## **Evanston Public Library Ventilation Fan Upgrade**

**Bid # 22-07**

### **ADDENDUM No. 1**

**March 8, 2022**

M100

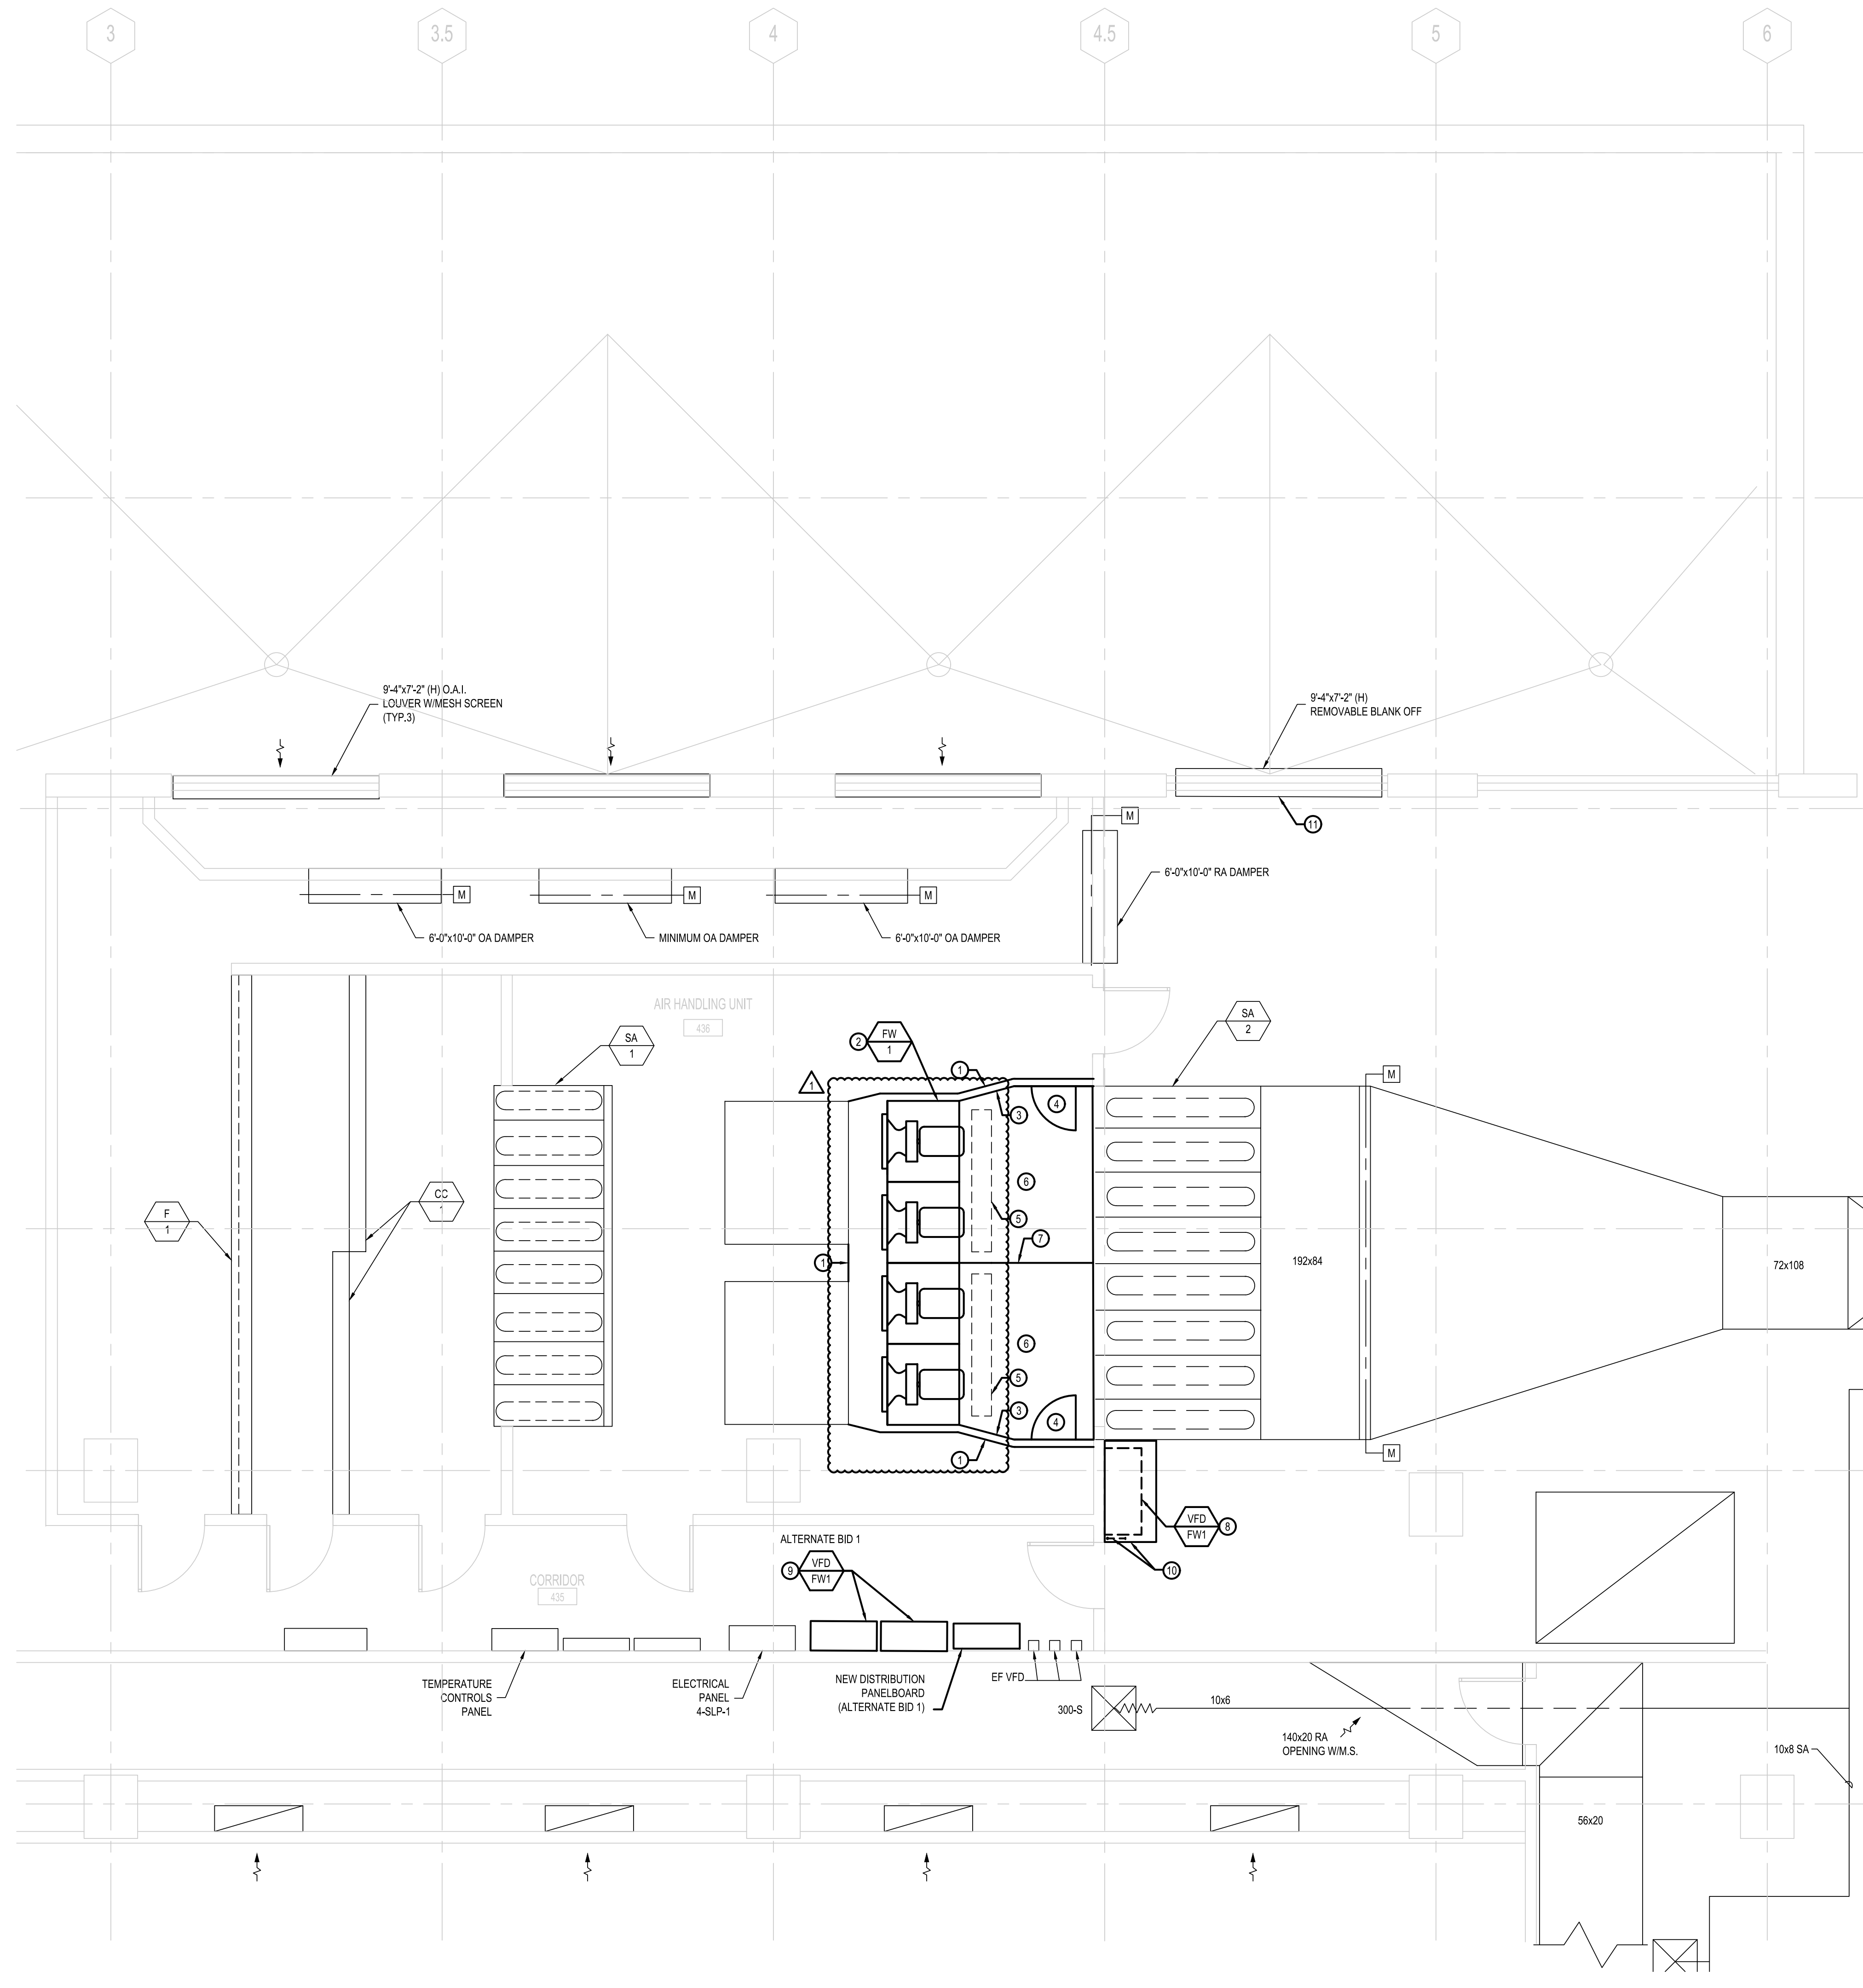
- 1. Drawings Sheet M100**
2. Location of hoist beam changed from outside of new plenum, to inside the new plenum. Beam was amended to include 2 sections.
3. Fan orientation was changed.
4. Notes I and J were added to General Notes section.

- I. CONTRACTOR IS RESPONSIBLE FOR DESIGNING, PROVIDING, AND INSTALLING ALL THRUST RESTRAINT FOR THE FAN WALL ASSEMBLY.
- J. THERE MUST BE FULL BLANKING ON THE UPSTREAM SIDE OF THE FANS.
